STAFF REPORT 03-11-2020 REGULAR MEETING PREPARED BY: A. PHILLIPS

APPLICATION NUMBER: 20-6654 **ADDRESS:** 3453 BURNS AVENUE

HISTORIC DISTRICT: INDIAN VILLAGE

SCOPE: REPLACE 35 HISTORIC WOOD WINDOWS WITH NEW WOOD, ALUMINUM-CLAD

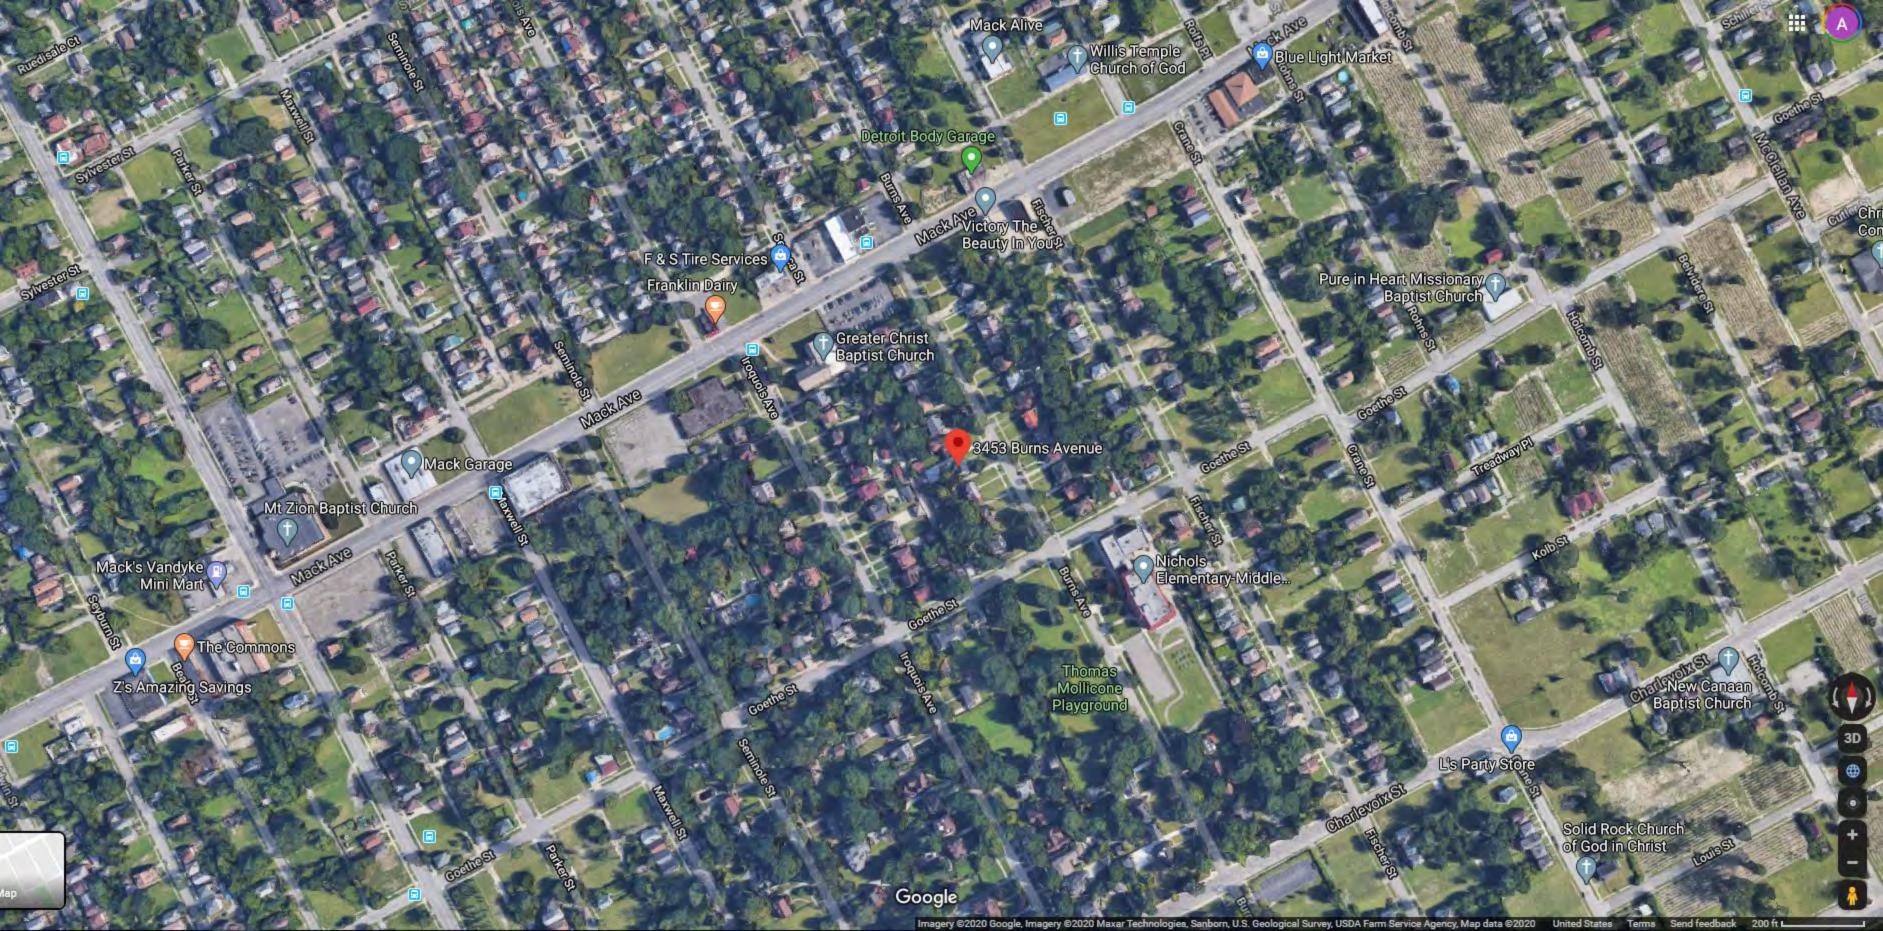
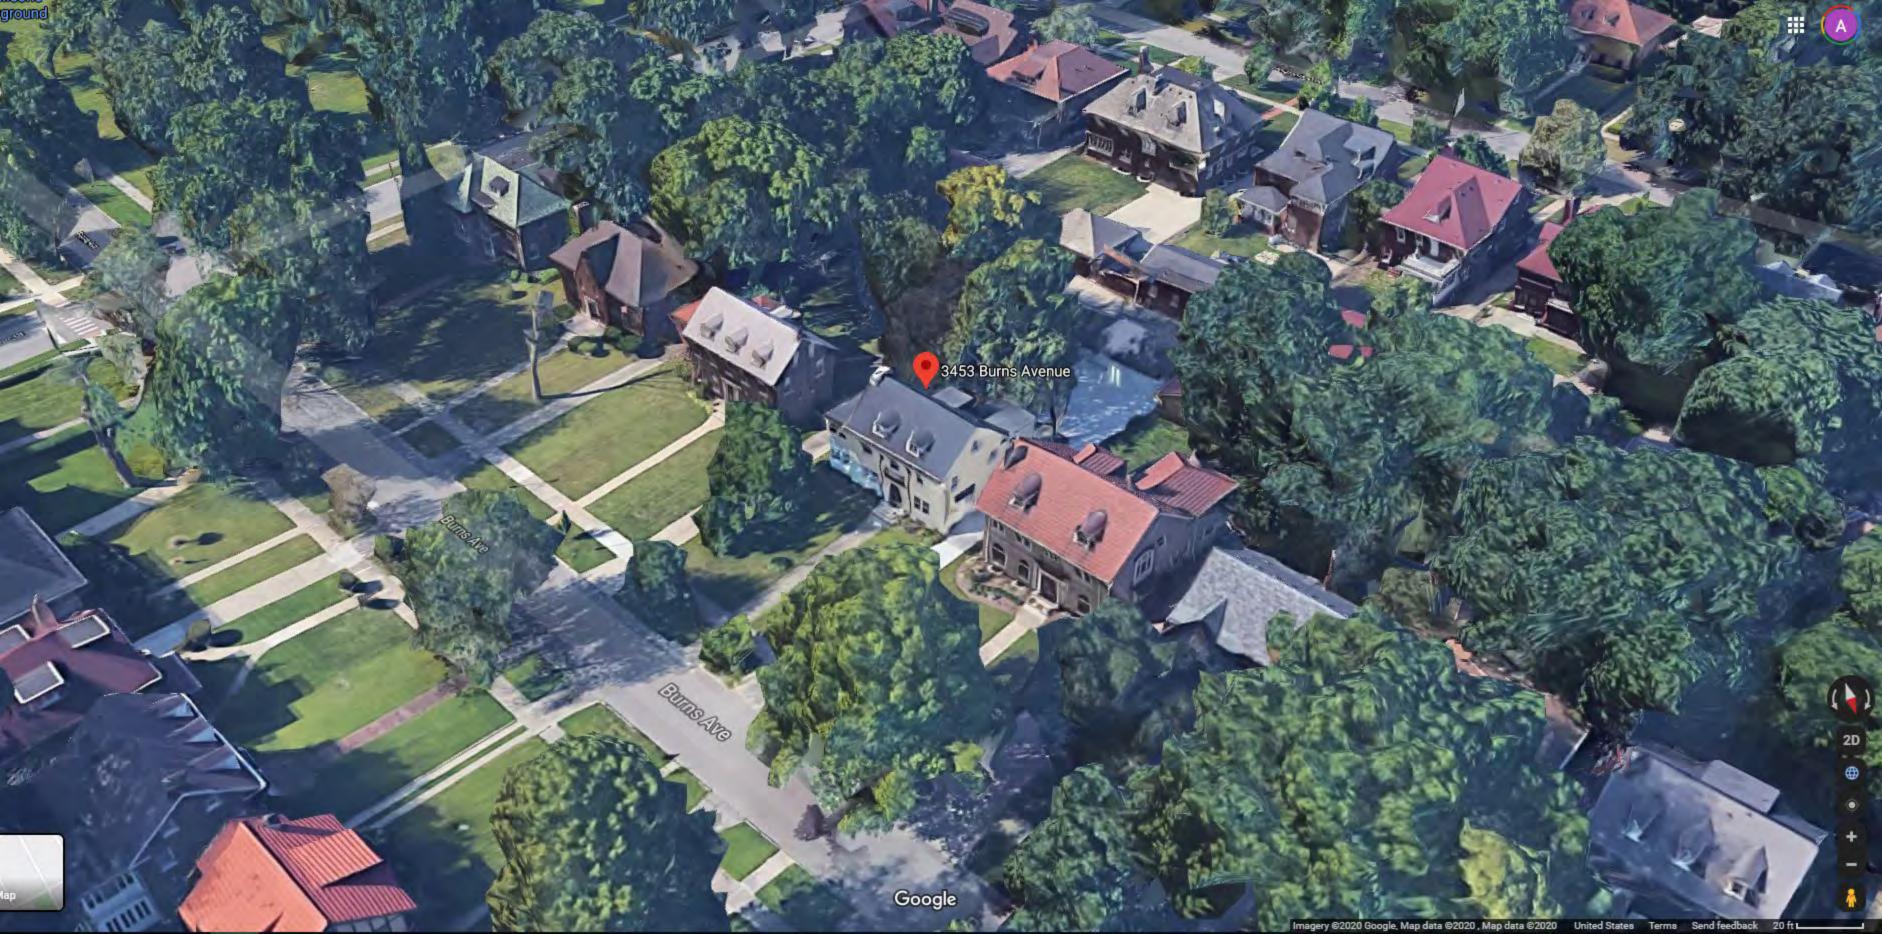
- The applicant is not specifically stating that the windows *require* replacement due to deterioration but rather that the property owner would *prefer* the replacement for other reasons including energy efficiency. See applicant statement for details.

- The historic/existing wood windows are character-defining features and examples of distinctive features and craftsmanship which characterize the property -- to replace them would destroy historic material which characterizes the property and its surrounding district.

- The windows maintain a high level of material integrity and this application does not demonstrate a level of deterioration requiring replacement and therefore does not meet the Secretary of the Interior's Standards.

- Neglect of window maintenance should not become a rationale for window replacement.
- The cost estimate for restoration of the windows (\$39,050.00) included in the applicant's submission is significantly less than the cost estimate for replacement (\$57,900).

It is staff's opinion that the work, as proposed, removes historic materials that characterize the property. Staff therefore recommends that the Commission deny a Certificate of Appropriateness as the proposed work does not meet the Secretary of the Interior's Standards for Rehabilitation, especially:
